UNITED STATES PATENT AND TRADEMARK OFFICE

APPLICATION NO.	FILING DATE	FIRST NAMED INVENTOR	ATTORNEY DOCKET NO.	CONFIRMATION NO.
10/034,926	10/29/2001	David M. Deboer	88066-5199	2483
28765	7590	08/25/2005	EXAMINER	
WINSTON & STRAWN LLP 1700 K STREET, N.W. WASHINGTON, DC 20006			THANH, LOAN H	
			ART UNIT	PAPER NUMBER
			3763

Office Action Summary

DETAILED ACTION

FIG. 10

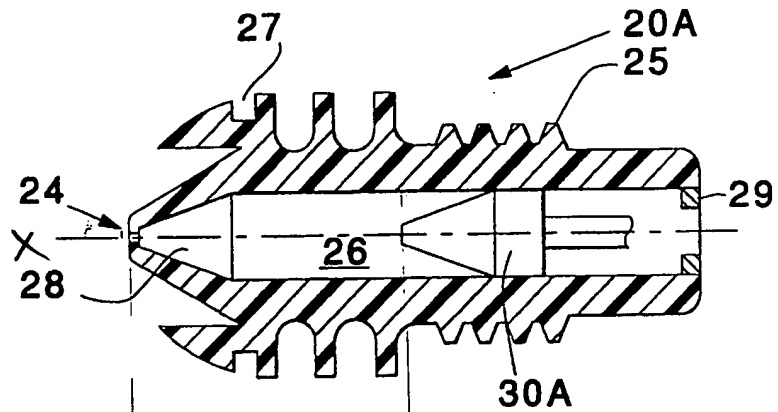
amendment to the claims to the length to diameter ratio is greater than 6/1. Lilley et al. still anticipates the claims. Applicant has not narrowed the claim to where the diameter of the channel is located. Thus in the broadest interpretation, Lilley et al. rejection is being maintained. See attached. The channel is considered to be the length of the probe in figure 10 and 11. The orifice is at the distal end but the channel is from the distal end all the way to the proximal end. As clearly shown the length is much larger than the diameter at an average of the diameter along the length or even at selected diameters taken along the x-axis. With respect to claim 22, since the lumen is circular, it would be inherent that the diameter is constant.

Applicant's arguments filed 06/16/05 have been fully considered but they are not persuasive. Applicant's arguments that the length to diameter ratio is not clearly shown is not persuasive. Applicant referred to figures 10-11. The length of the discharge tube is shown clearly with a taper. See element 24 and 28. The orifice 24 is very small and it is considered to be clearly shown that the length of the channel to the diameter of the orifice is greater than 6/1.
